CITY PLAN COMMISSION**THURSDAY, MARCH 21, 2024****FILE NUMBER:** S234-069**SENIOR PLANNER:** Sharmila Shrestha**LOCATION:** Empress ROW at Viceroy Drive, west of Stemmons Freeway/Interstate Highway No. 35E**DATE FILED:** February 22, 2024**ZONING:** PD 1012**PD LINK:** [Article 1012.pdf \(dallascityhall.com\)](#)**CITY COUNCIL DISTRICT:** 6**SIZE OF REQUEST:** 21.028-acres**APPLICANT/OWNER:** The Salvation Army**REQUEST:** An application to replat a 21.028-acre tract of land containing part of Lot 1 in City Block 4/7491 to create one lot on property located on Empress ROW at Viceroy Drive, west of Stemmons Freeway/Interstate Highway No. 35E.**SUBDIVISION HISTORY:**

PRELIMINARY PLAT - LOT 1R, BLOCK 4/7491, THE SALVATION ARMY DALLAS CAMPUS ADDITION

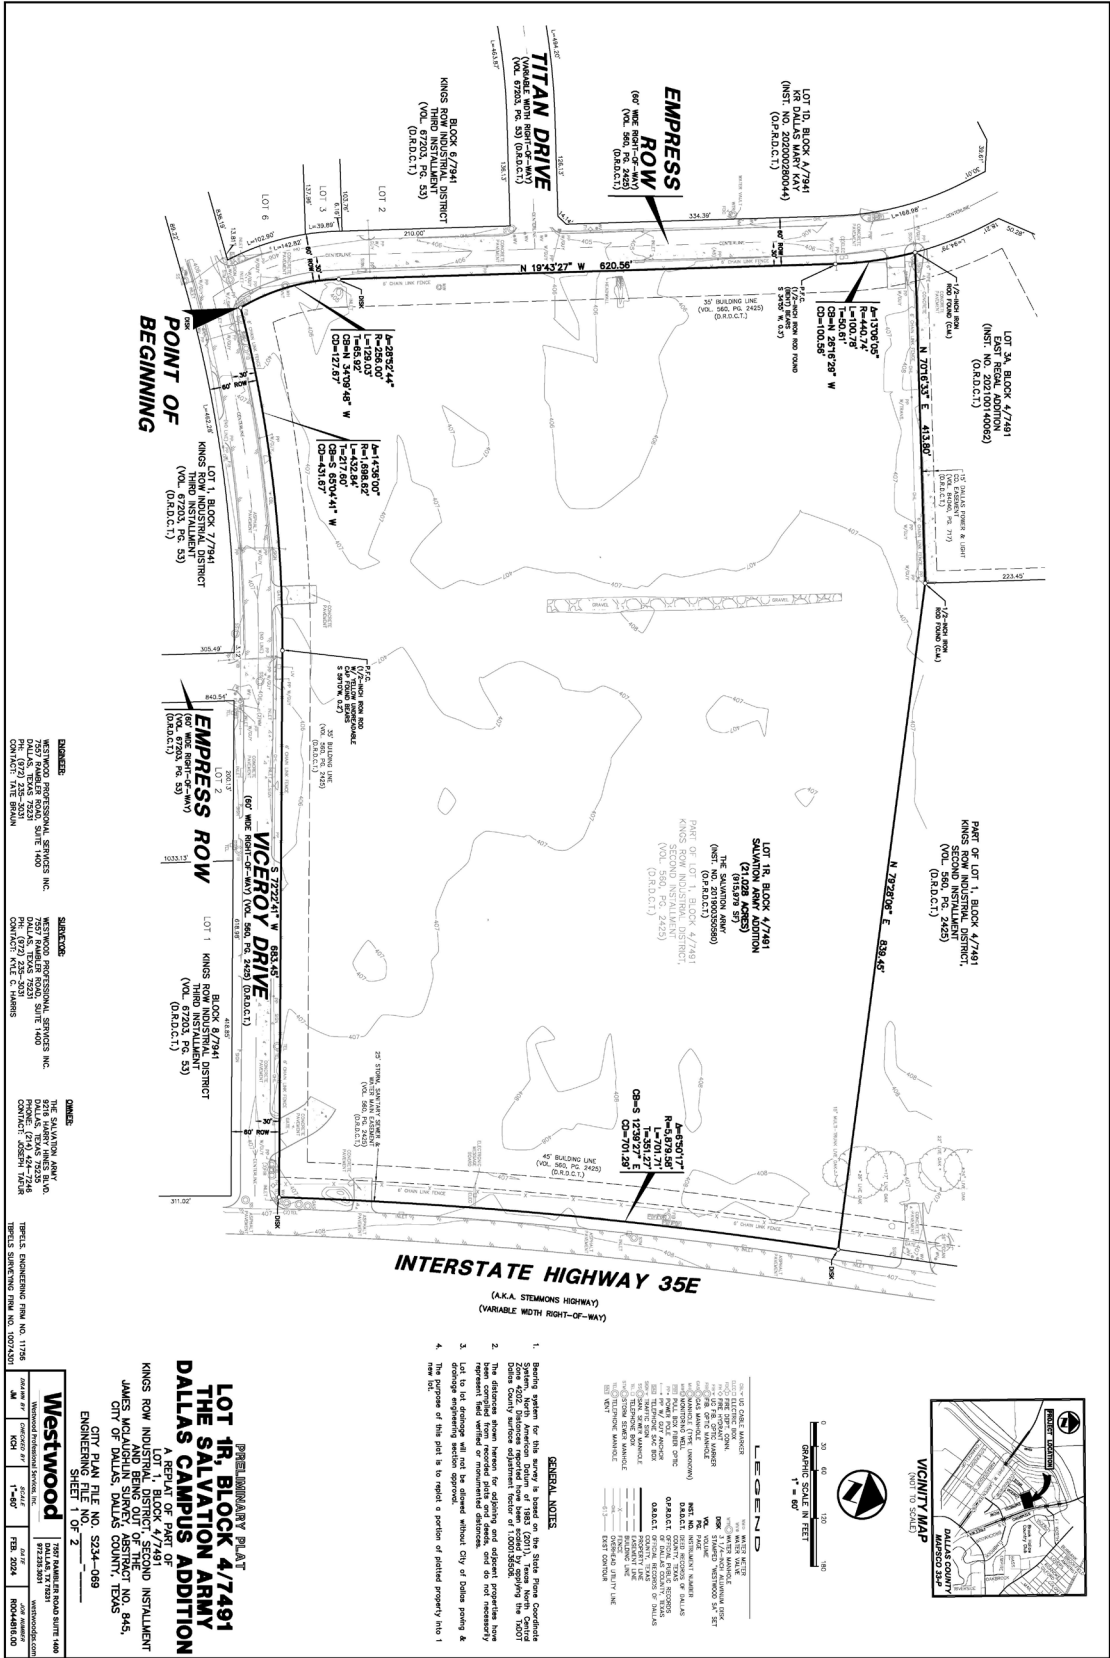
15. On the final plat, dedicate a minimum 5-foot by 5-foot corner clip (via fee simple or street easement) at the intersection of Empress ROW and Viceroy Drive. Section 51A 8.602(d)(1)
16. A larger corner clip may be requested during engineering plan and traffic review to accommodate an adequate turning radius, or to maintain public/traffic appurtenances, within the area of the corner clip. Section 51A 8.602(d)(1), 51A 8.608(a)
17. TxDOT approval may be required for any driveway modification or new access point(s).

26. On the final plat, change “Interstate Highway 35E” to “Stemmons Freeway/Interstate Highway No. 35E”.
27. Correct block number on plat to 4/7941.

28. On the final plat, change “Titan Drive” to “Titan Drive (AKA Titan ROW)”.
29. On the final plat, identify the property as Lot 1C in City Block 4/7941.
